971, 9YA– Requested Active Charcoal Container Replacement in Connection with Tank Vent Valve Replacement for P044100/ P044200

Revision History

Figure 1

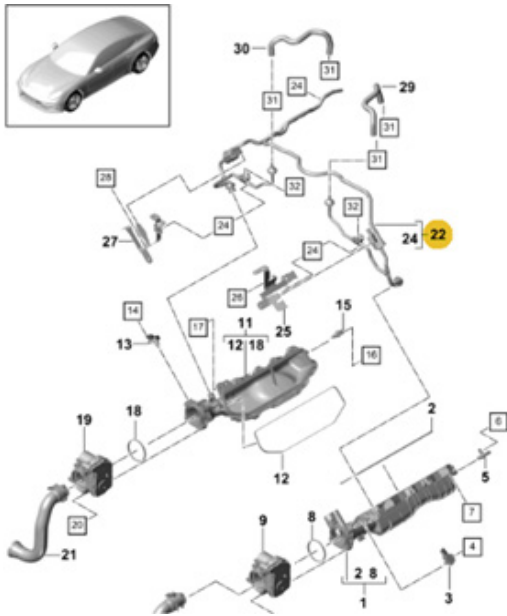
Please replace the Breather Line (Part 22) shown below.

Figure 2

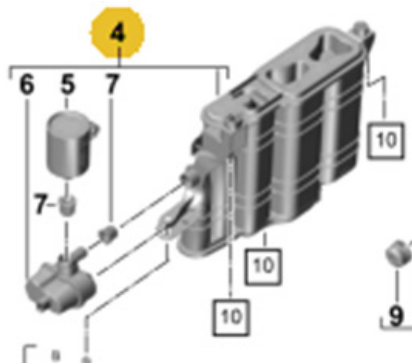
In the same PQIS entry and warranty request used to replace the Breather Line insuring the proper repair of the vehicle, please replace the filter element (Part 5) shown below. (The filter element can be replaced by ordering the pre-assembled unit represented by Assembly "4" in Figure 2.)

Figure 3

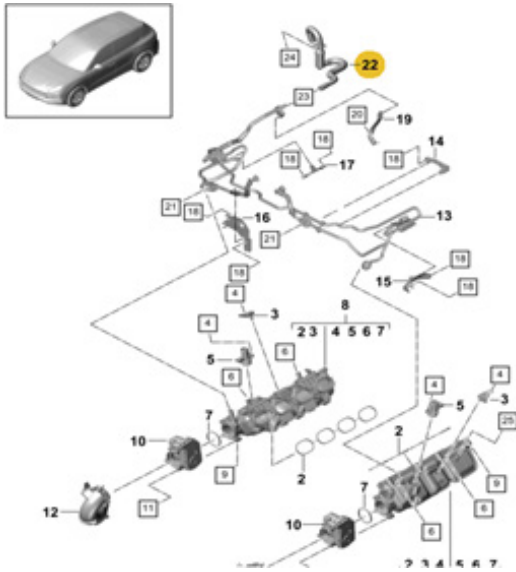
Please replace the Breather Line (Part 22) shown below.

Figure 4

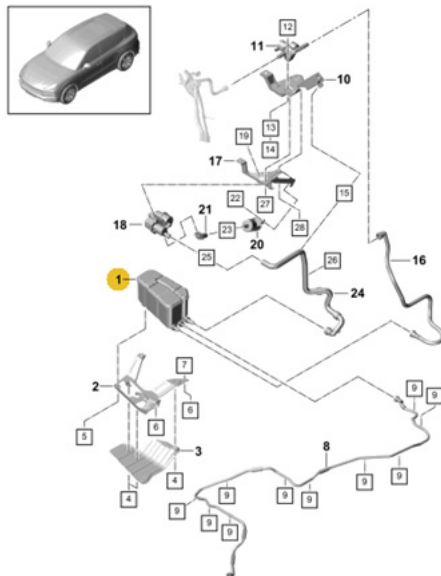
In the same PQIS entry and warranty request to replace the Breather Line to properly repair the vehicle, please replace the charcoal container (Part 1) shown below.
